## SICHERHEITSMITTEILUNG für Gurtzeuge

Nummer: 03/2013

# SERVICE BULLETIN SPSB009

SUBJECT: SUPPLIER/VENDOR RECALL OF PS70104 HOUSINGS (METAL FLEX HOISING INC)

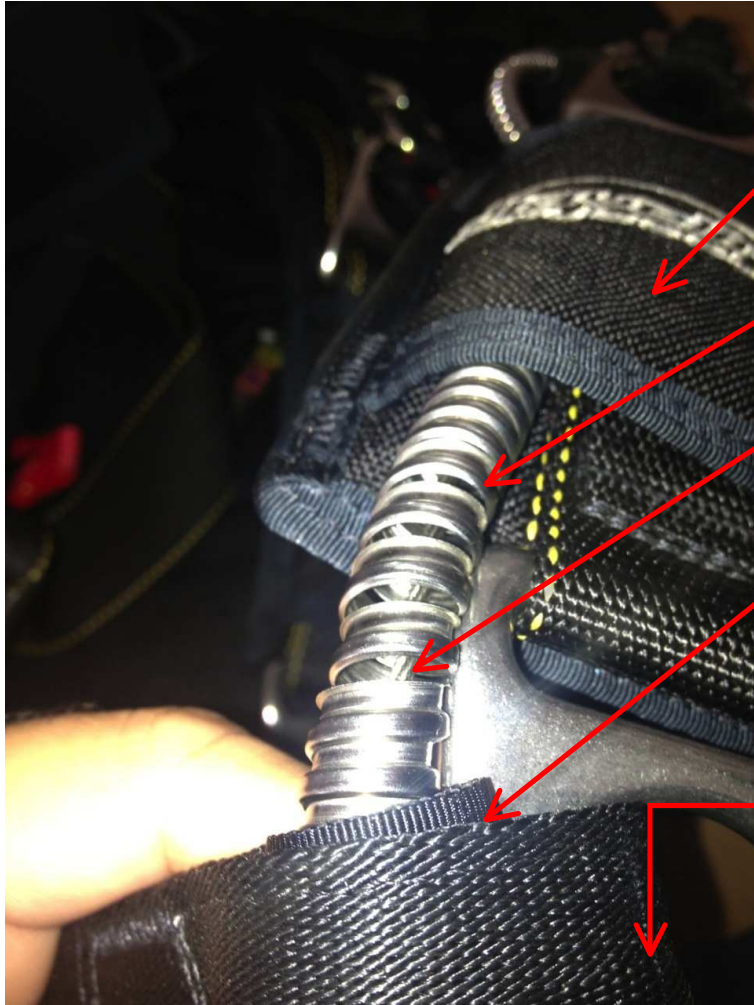
**Who can inspect:** Anyone can inspect this area. See photos below.

RESERVE RIPCORD HOUSING (LOWER END)

SEPERATED HOUSING (FOR REFERENCE)

**What to inspect:** All JA101-XX harness container systems listed in table above. Inspect Reserve Ripcord housing.

If the serial number is listed in the above table, inspect the available exposed reserve ripcord housing. Locate the lower end of the housing, which is clamped to the Main Lift Web, just above the reserve ripcord pocket. Inspect the exposed length of housing from the clamp upwards; ensure that the coil has not separated/unraveled. Be sure to inspect the section that is routed through the chest strap.

A. HOUSING FOUND TO BE INTACT (GOOD): The rig may continue to be jumped with periodic monitoring until the next repack cycle or earlier elective replacement. However this housing must be replaced at the next repack cycle. See <http://www.sunpath.com/support/HousingReplacement.pdf> for instructions for your rigger to complete the replacement of the housing.

B. HOUSING FOUND TO BE SEPERATED/UNRAVELLED (BAD): The housing must be replaced before the next jump by a certificated senior or master parachute rigger (or foreign equal) or the manufacturer. See <http://www.sunpath.com/support/HousingReplacement.pdf> for instructions for your rigger to complete the replacement of the housing or instructions to send your system back to the manufacturer.
